**Memorandum**

Subject: REVIEW OF WORKPLAN FOR BENCHMARK  
TECHNOLOGY IN CITY OF INDUSTRY

**SUBJECT: WORKPLAN FOR CONDUCTING SUBSURFACE INVESTIGATION,  
BENCHMARK TECHNOLOGY FACILITY, 200 SOUTH TURNBULL  
CANYON ROAD, CITY OF INDUSTRY  
(LARWQCB FILE NO. 86-22)**

<b>Woodward-Clyde Consultants</b> 	
BENCHMARK TECHNOLOGY FACILITY MAP SAMPLING LOCATIONS	
Project No. 42202A	Fig.
BENCHMARK SOILS	1

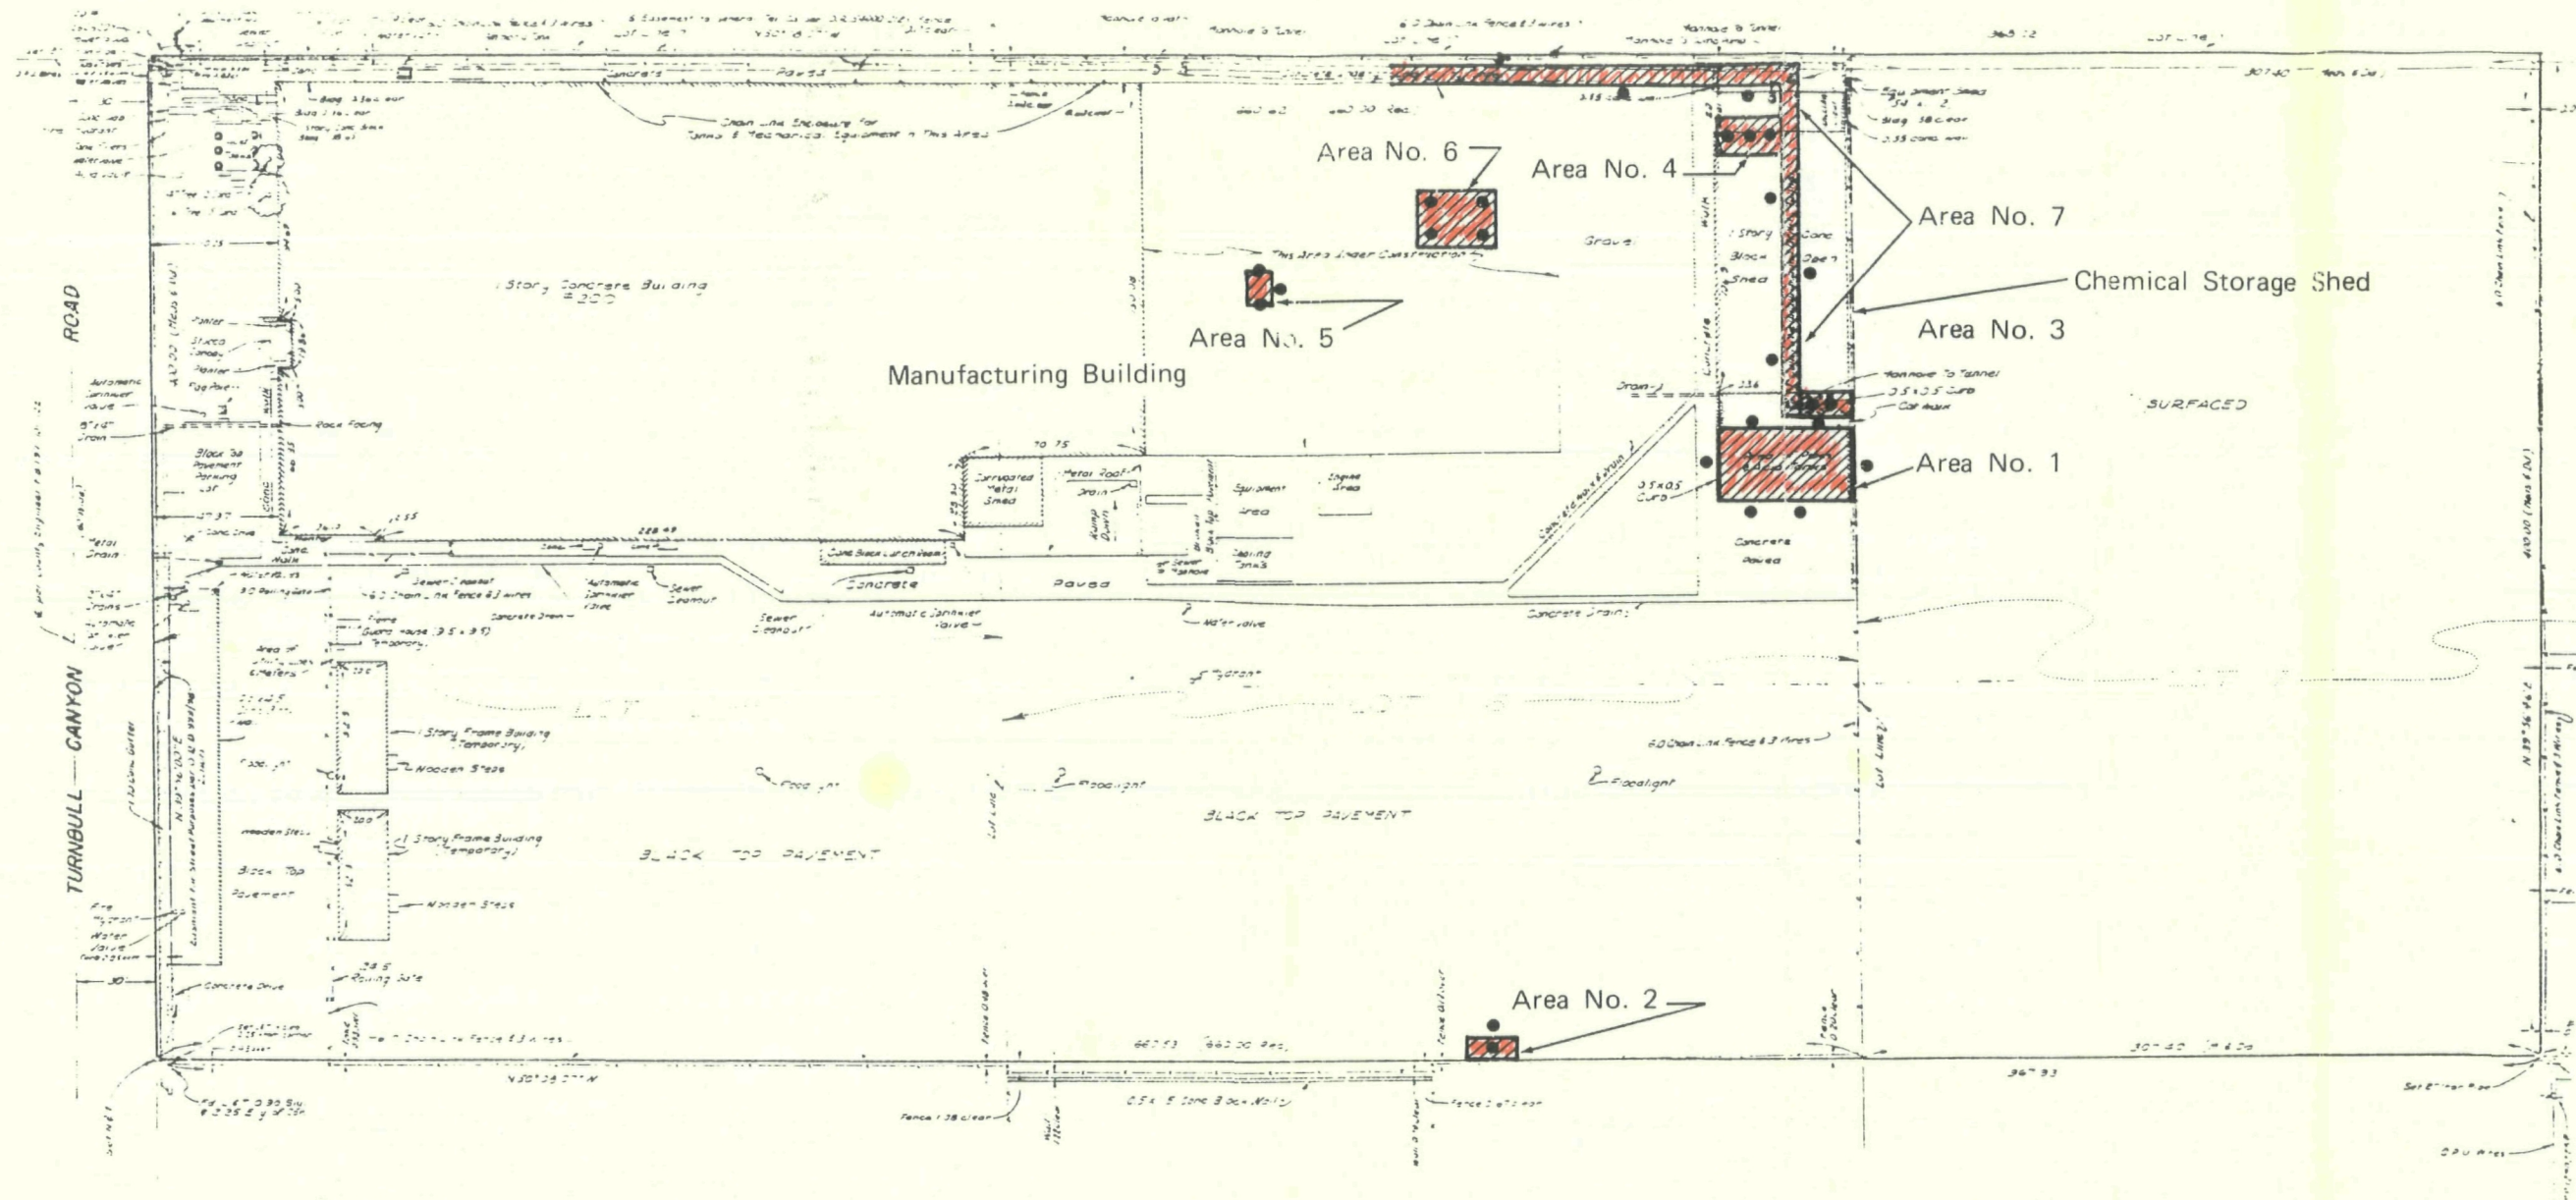
9. The final report should contain a better map. One that is readable.
10. The direction of ground water flow should be determined based on available data. Some consideration should be given to sampling soil gas downgradient from the potential sources. Because solvent use at the site has substantially decreased over the last 3 to 4 years, plume may have migrated sufficiently downgradient to be out of the proposed sampling area. The proposed method of sampling only measures chemicals in the pore gases and not chemical adsorbed to soil particles. Therefore, the presence of chemicals in the soil will not be thoroughly evaluated. Since the purpose of the investigation is to determine if a discharge to ground water has occurred, some sampling of the ground water downgradient of the site is recommended.
